AGENDA
PLANNING AND ZONING COMMISSION MEETING
CITY OF CREVE COEUR, MISSOURI
MONDAY, JUNE 19, 2017
6:30 PM

**APPLICATION TO PLANNING AND ZONING COMMISSION
#17-020 FOR A SITE DEVELOPMENT PLAN FOR A NEW MULTI-
TENANT RETAIL BUILDING AT 10453 OLIVE BOULEVARD WITHIN
CREVE COEUR PAVILION SHOPPING CENTER**

REQUEST: Altus Properties, manager of Cornerstone Retail Fund I, LLC, has submitted an application for site development plan approval for a new 6,000 square foot multi-tenant retail building at 10453 Olive Boulevard within the Creve Coeur Pavilion Shopping Center, adjacent to the recently approved Panda Express Restaurant.

Figure 4: Close-up of the Landscape Plan

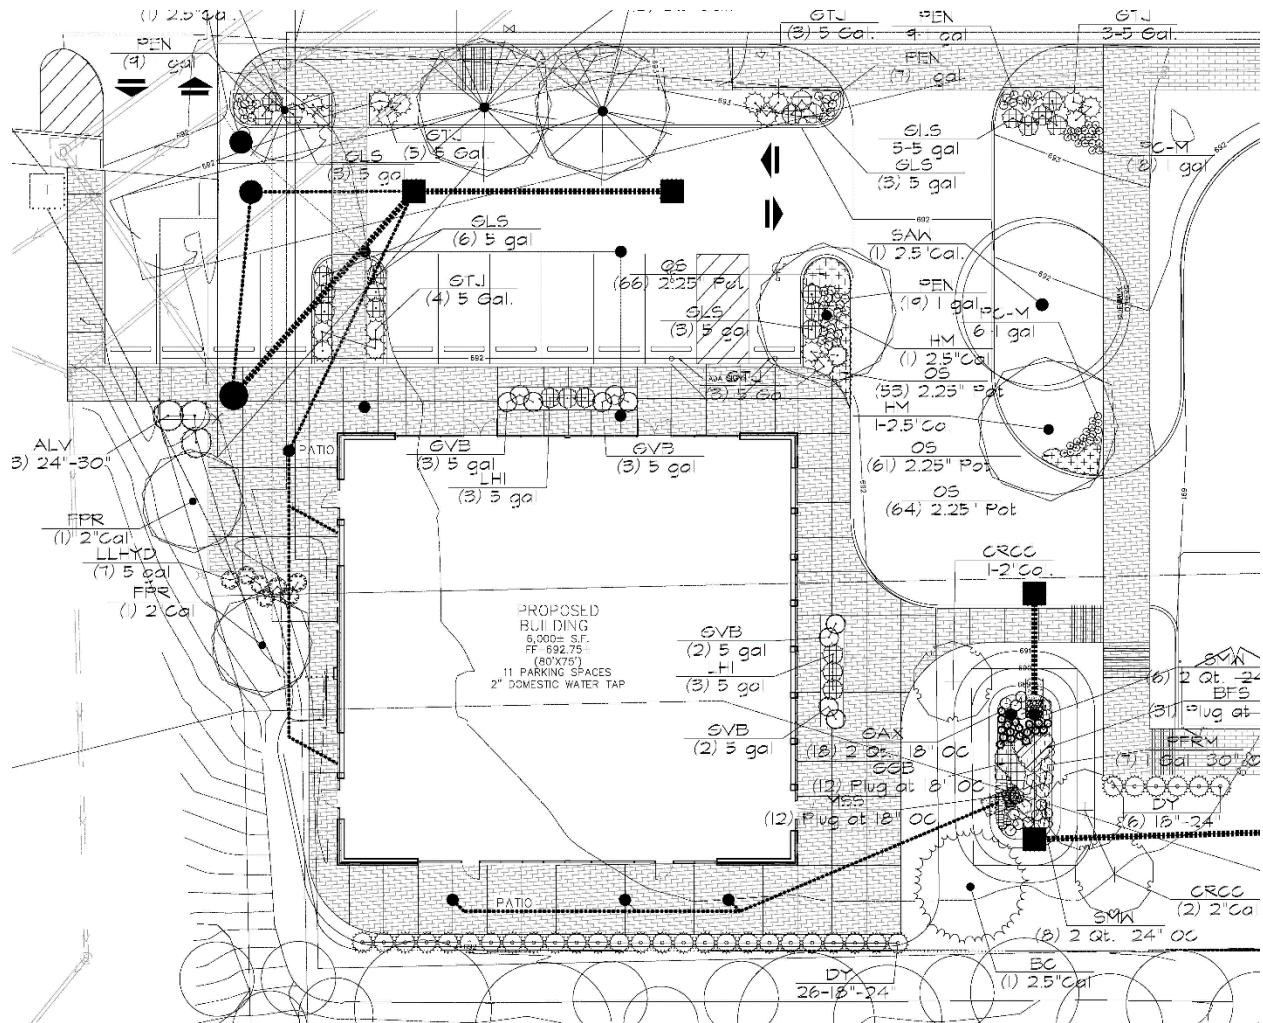
The Design Guidelines encourage high quality landscape designs that minimize the appearance of the parking lot, accentuate the building and site, and aide vehicular and pedestrian circulation. Landscaping should provide for consistency in design throughout a development, while also allowing for distinction of site elements and the relationship to the building.

Overall, the Landscape Plan is consistent with the recommendations of the Design Guidelines, as well as with the adjacent development. However, one area that appeared to be lacking in plantings was that adjacent to the patio area and stormwater area, shown below. Therefore, Staff has included a condition of approval that a revised Landscape Plan be submitted for the Zoning Administrator's approval that carries the design around from the patio area northward, to coincide with the fence (not shown in this drawing).

5. The Landscape Plan shall be amended to include additional plantings along the east pedestrian area that is consistent with the design of the rest of the development, and with the requirements Section 405.540 Landscaping.
